South Texas Project Electric Generating Station P.O. Box 289 Wadsworth, Texas 77483

May 10, 2010
U7-C-STP-NRC-100106

South Texas Project
Units 3 and 4
Docket Nos. 52-012 and 52-013
Response to Requests for Additional Information

Attached are responses to NRC staff questions included in Request for Additional Information (RAI) letter number 324 related to Combined License Application (COLA) Part 2, Tier 2 Section 10.2 Turbine Generator. This letter completes the response to RAI letter number 324.

Figure 10.2-5 Turbine Overspeed Trip System Functional Diagram

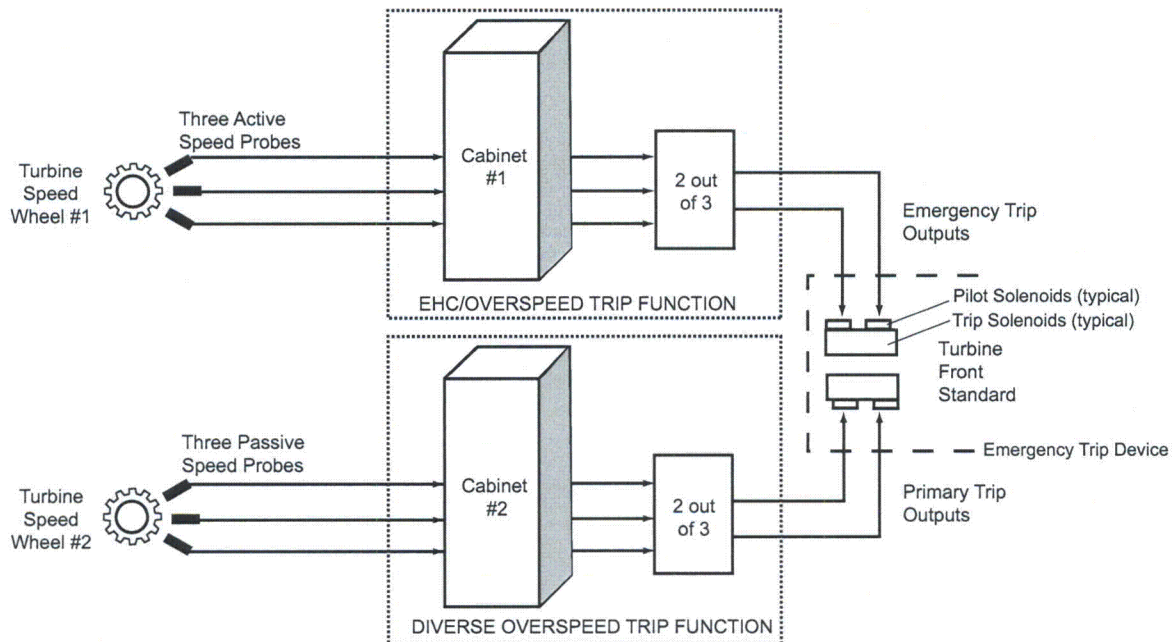
1. the schematics and logic diagrams for the two electric overspeed systems;
2. explain whether each of these two emergency overspeed systems have their own power source and are installed in separate areas.
3. a site specific ITAAC in Part 9 of the COLA (which includes a report to confirm the design and hardware/firmware diversity of these two electric overspeed systems);

The overspeed protection system consists of the primary overspeed trip function and the emergency overspeed trip function, as illustrated in the attached figure. Relative to each other the primary and emergency overspeed trip functions are independent, redundant and diverse up to the solenoid operated pilot valves on the trip solenoid valves. The trip solenoid valves are redundant and independent.

As a result of this RAI response, COLA Part 2, Tier 2, Subsection 10.2.2.4 will be revised, a new Figure 10.2-5 added, and a new table will be added to COLA Part 9, Section 3.0 Site Specific ITAAC as follows.

The Primary and Emergency electrical overspeed trip modules each consist of three independent circuits. Each circuit monitors a separate speed signal and activates trip logic at specific speed levels. Refer to Figure 10.2-5, Turbine Overspeed Trip System Functional Diagram. The primary overspeed trip function is redundant and utilizes three passive speed magnetic pickups that are separate from the active speed sensors used for normal speed control emergency trip function. Each speed signal is compared to a speed setpoint of approximately 110% of rated speed, and produces trip signals arranged in two-out-of-three logics, to de-energize the solenoid operated pilot valves of one of the two trip solenoid valves of the electro-hydraulic ETD. Both solenoid operated pilot valves must be de-energized to trip the associated trip solenoid valve. The ETD has two redundant trip solenoid valves. Tripping of either redundant trip solenoid valve will drain the emergency trip fluid, resulting in a turbine trip.

The following figure will be added to COLA Part 2, Tier 2, Section 10.2.
